ADDENDUM NO. 04

PROJECT: BRADFORD CSD - 2023 CAPITAL IMPROVEMENT PROJECT

DATE: 04/04/2025

1 ROOF HVAC NEW WORK PLAN - AREA 1
 H202.1 1/8" = 1'-0"

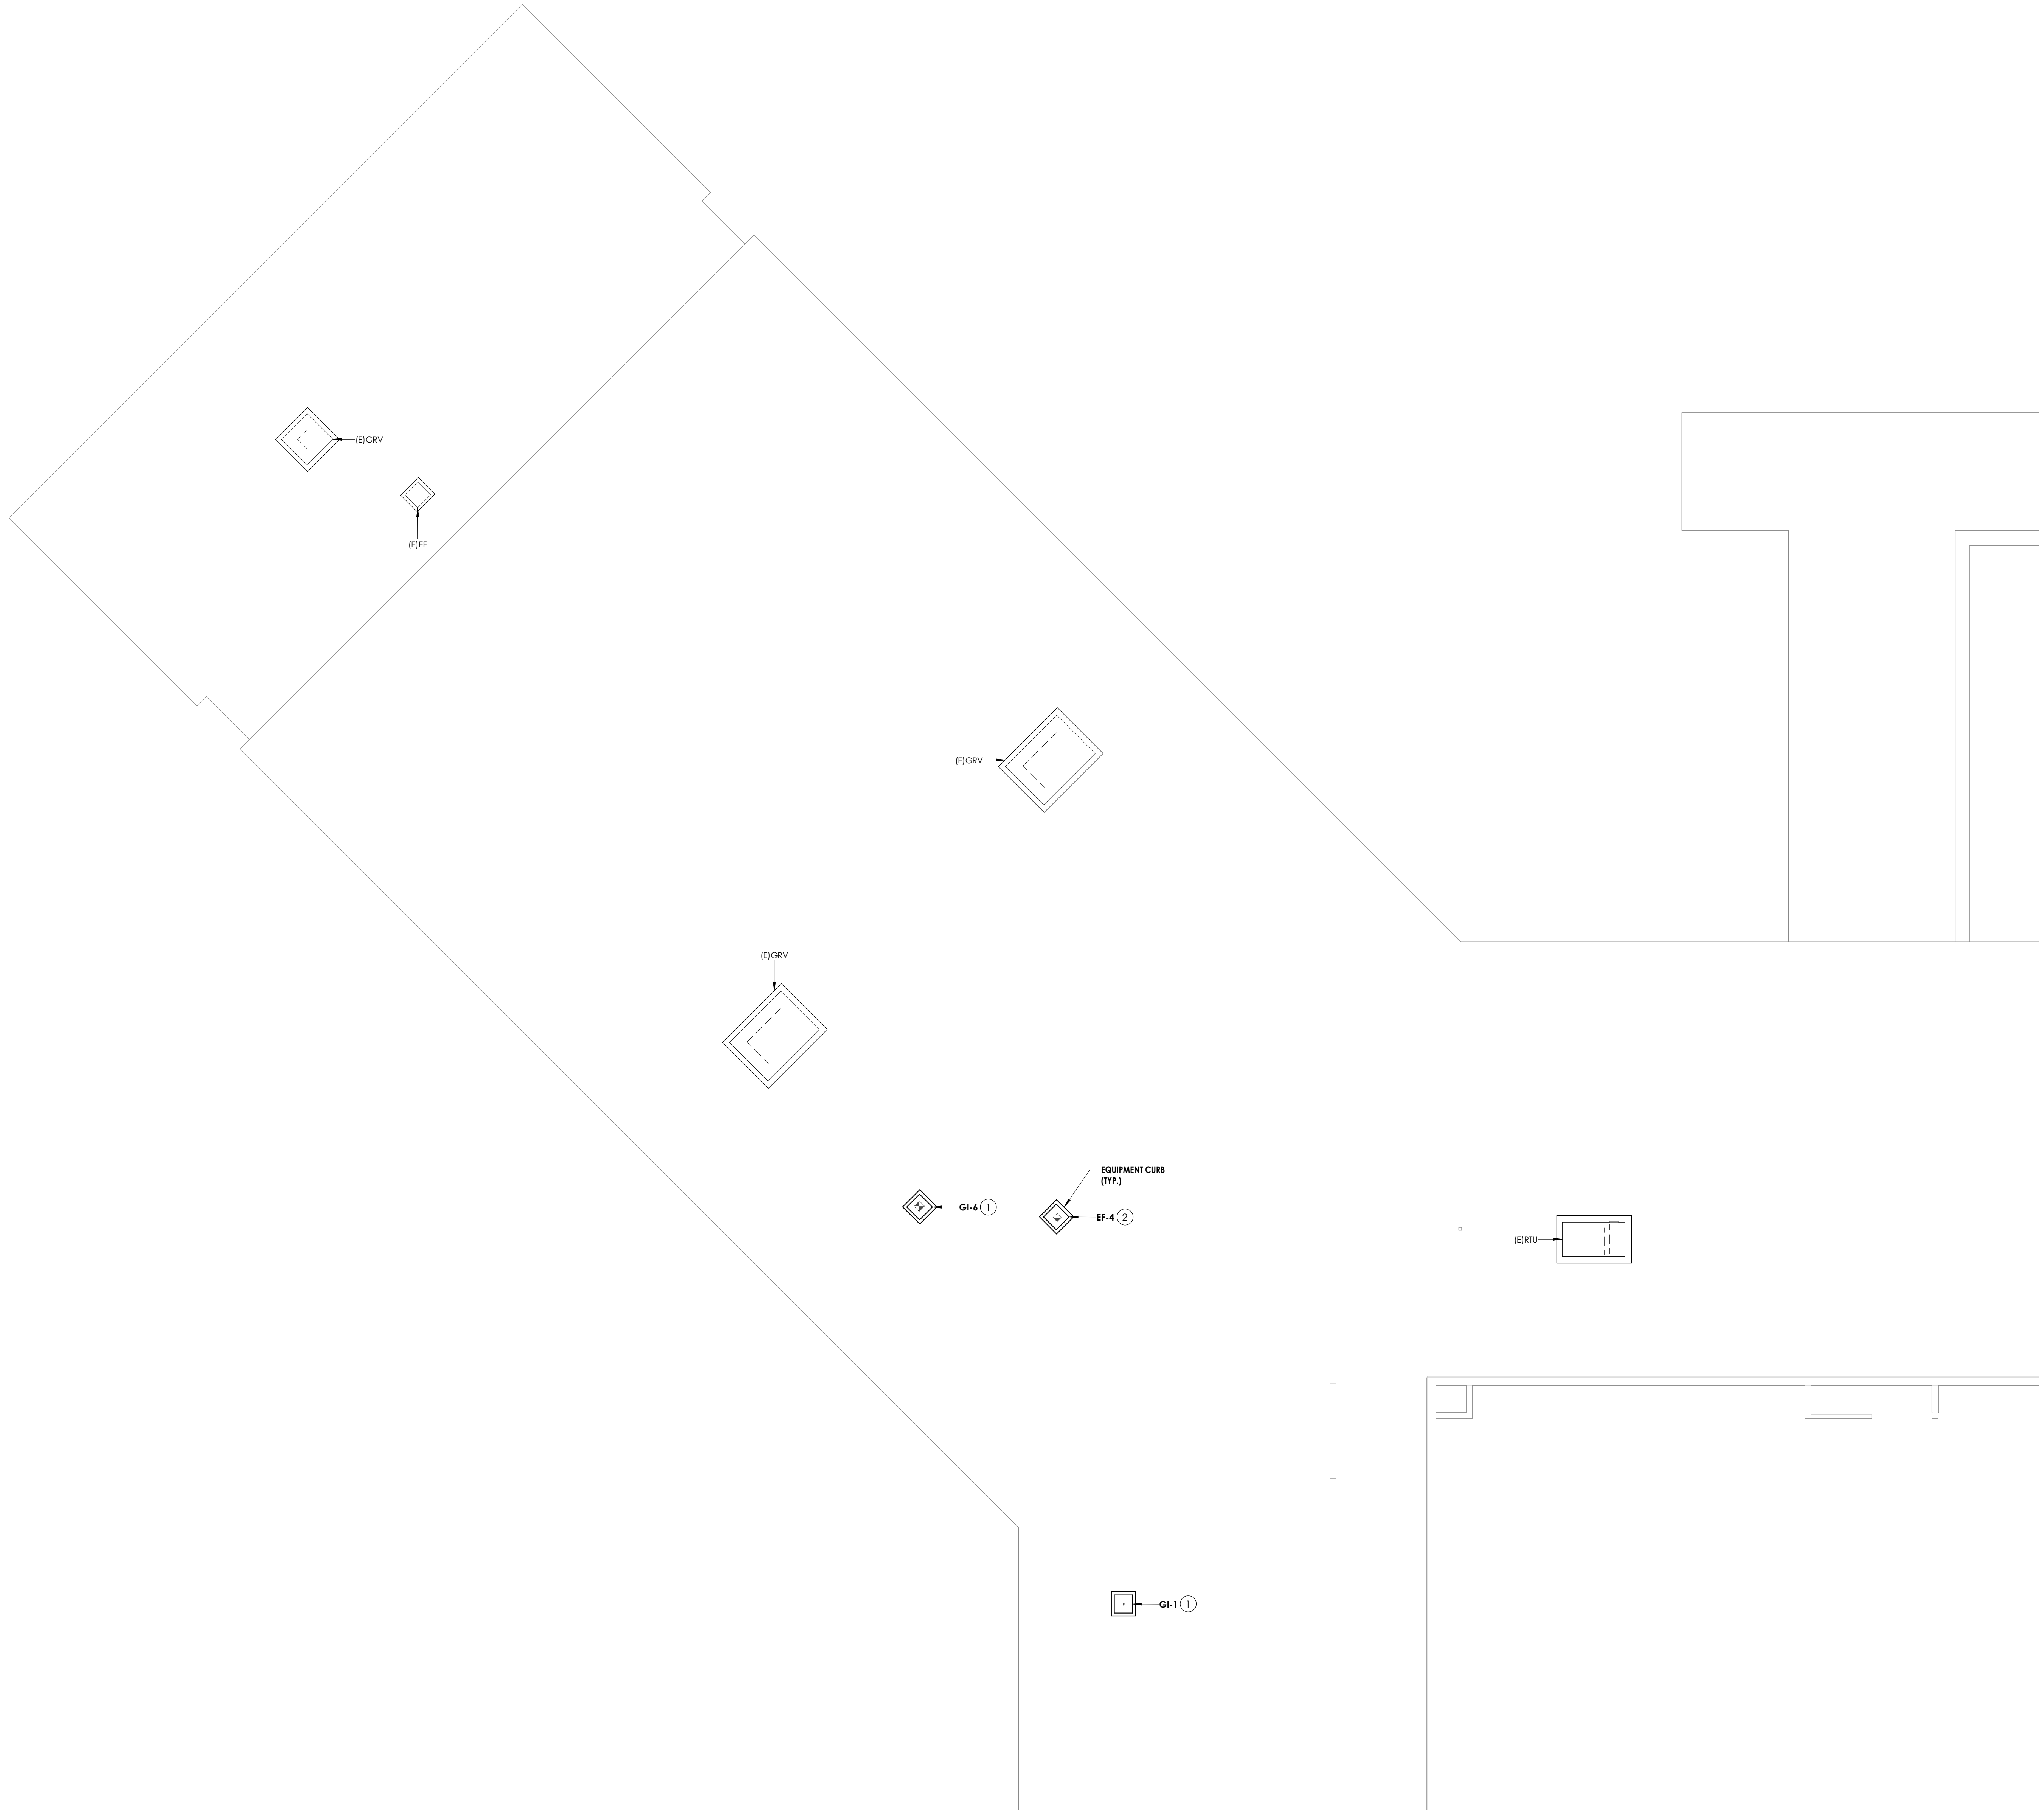
QUESTION: Please clarify the scopes of work for the GC and MC as it pertains to the roof work required for installation of equipment curbs, rails, and pipe portals. Currently shown and noted on MB A-202 & 800 and on MB H-202.1, 202.2, 202.3, 202.4, H302.1, 302.2, 302.3, 302.4

| MB-H202.1 | REMOVED/EDIT COMMENTS TO CLARIFY CONTRACTOR SCOPE OF WORK. |

RESPONSE: All work associated with mechanical work is the responsibility of the mechanical contractor. This includes installation of curbs, rails, and pipe portals. The mechanical contractor is also responsible for cutting, patching, and sealing of roof openings for mechanical equipment. The only work by the general contractor associated with mechanical work will be the structural support steel below the deck as necessary (see RFI FC-05 attached).

1 ROOF HVAC NEW WORK PLAN - AREA 2
H202.2 1/8" = 1'-0"

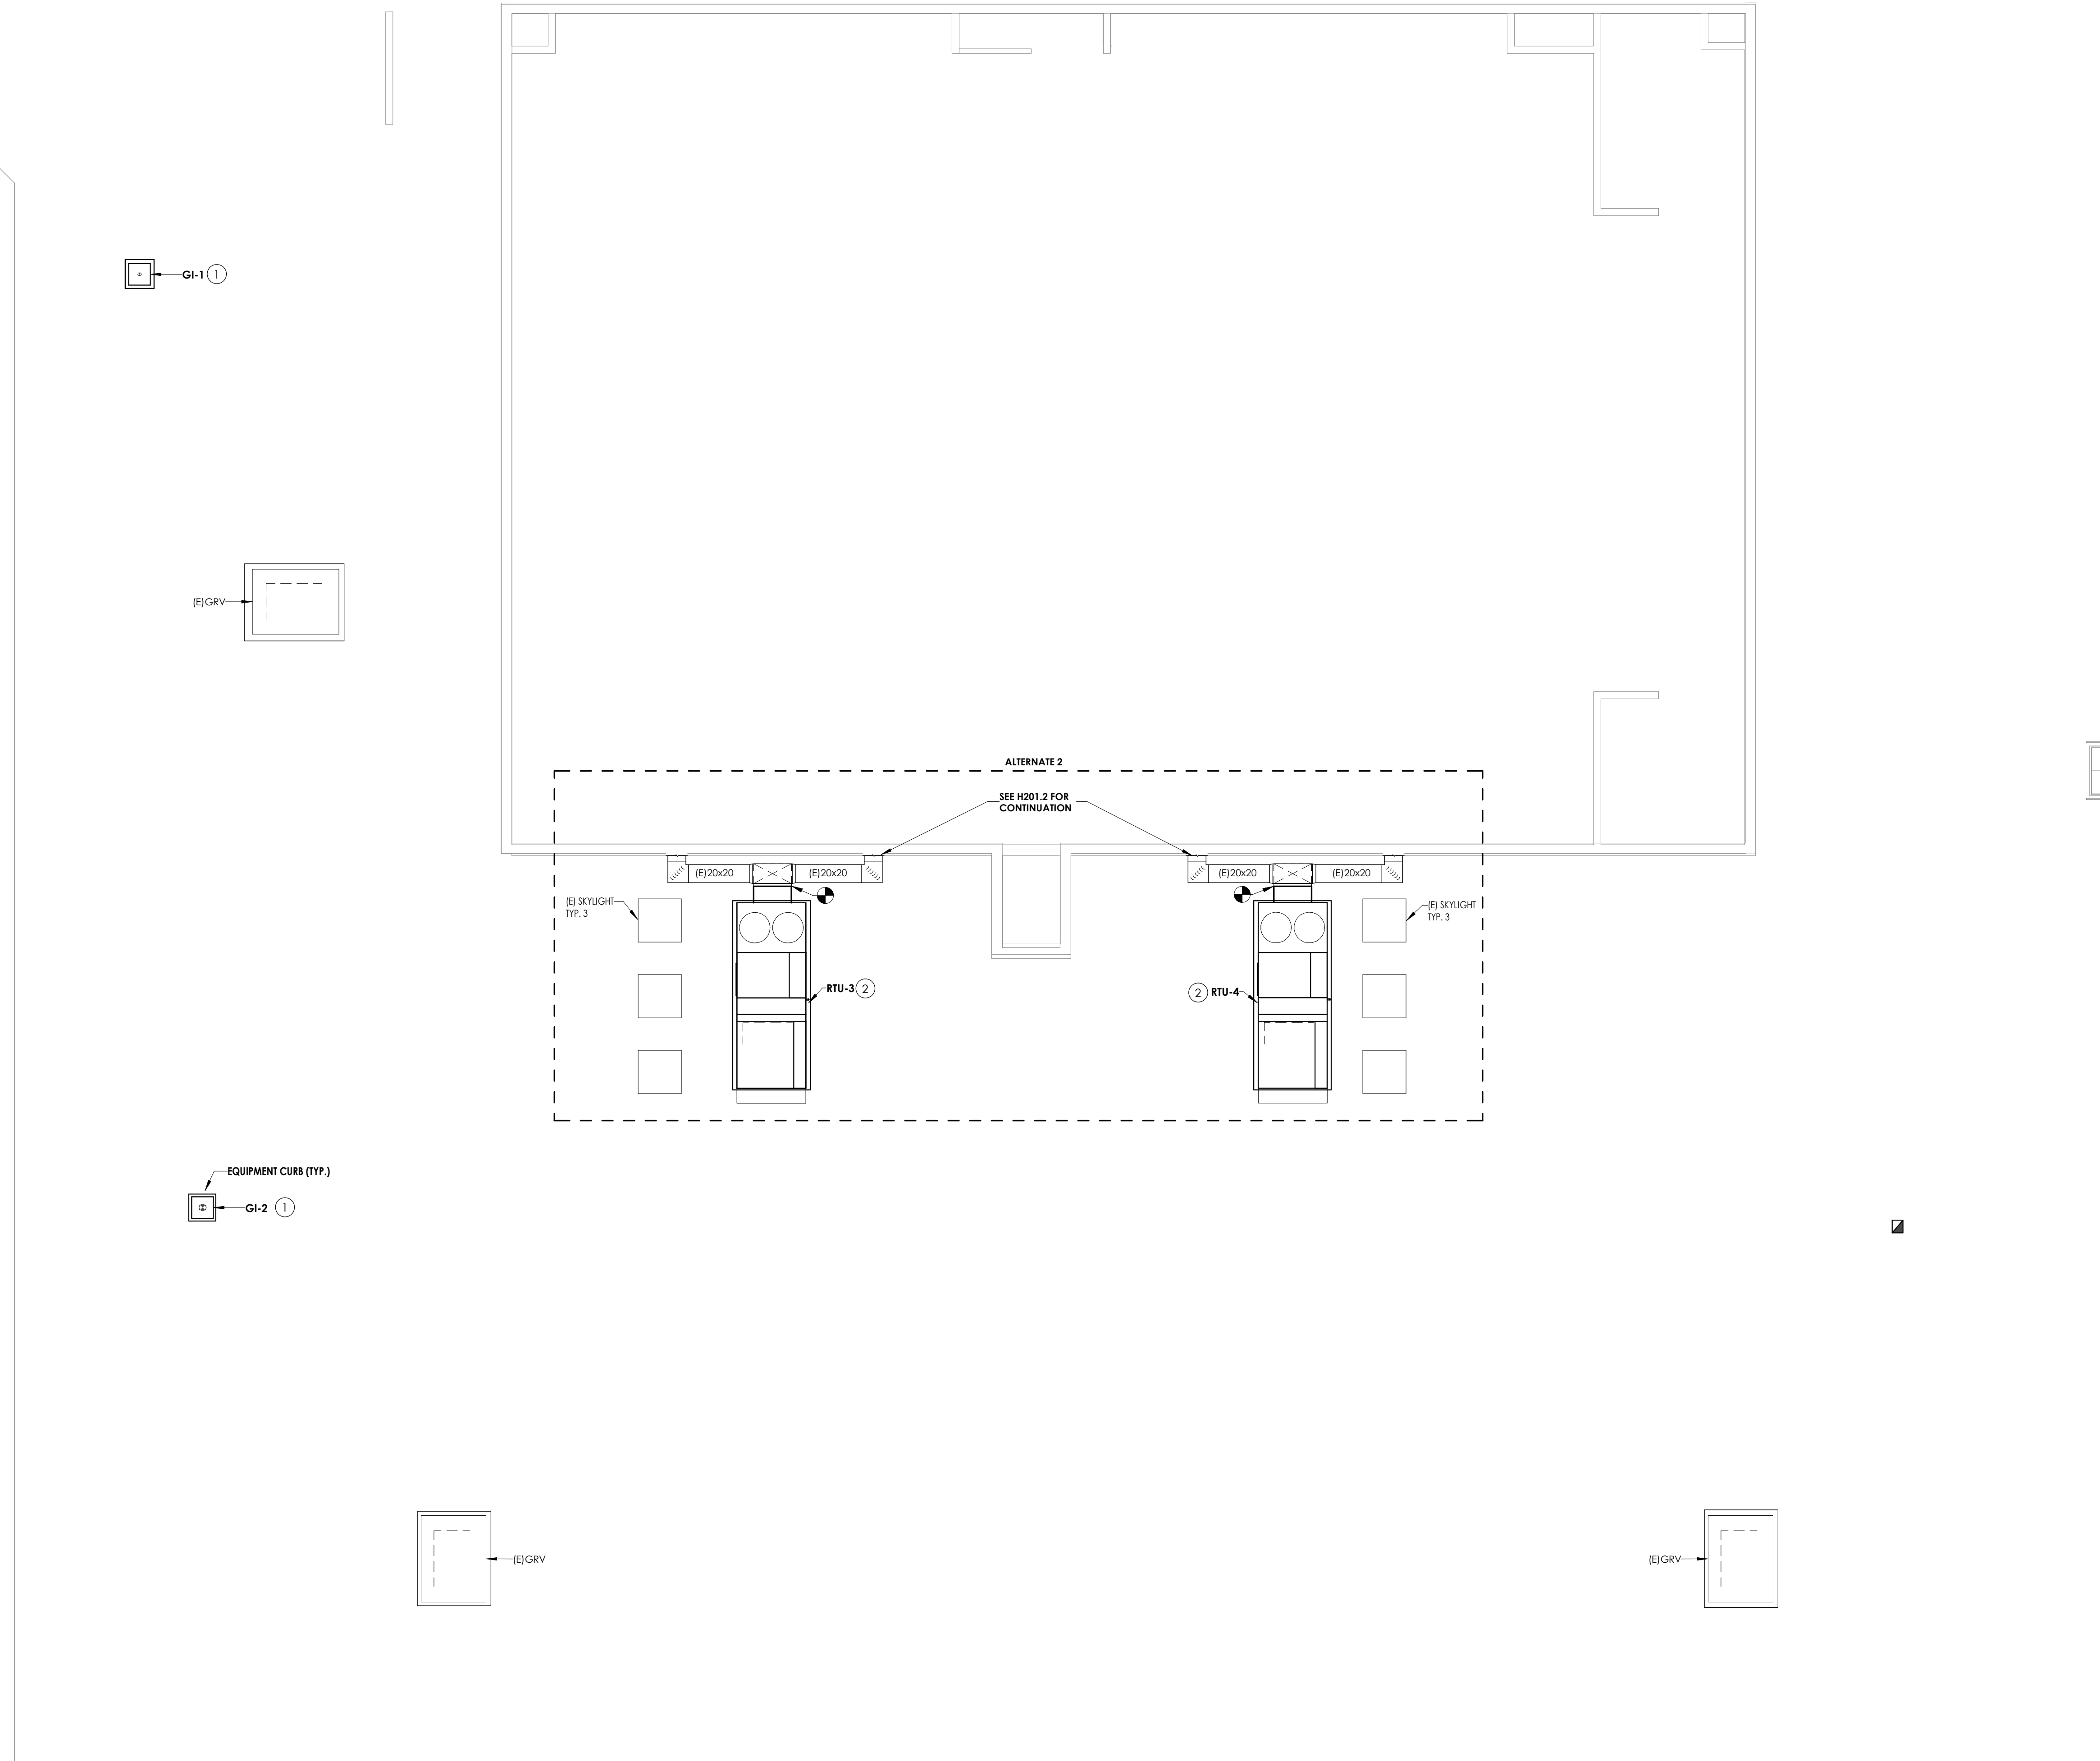
| MB-H202.2 | REMOVED/EDIT COMMENTS TO CLARIFY CONTRACTOR SCOPE OF WORK. |
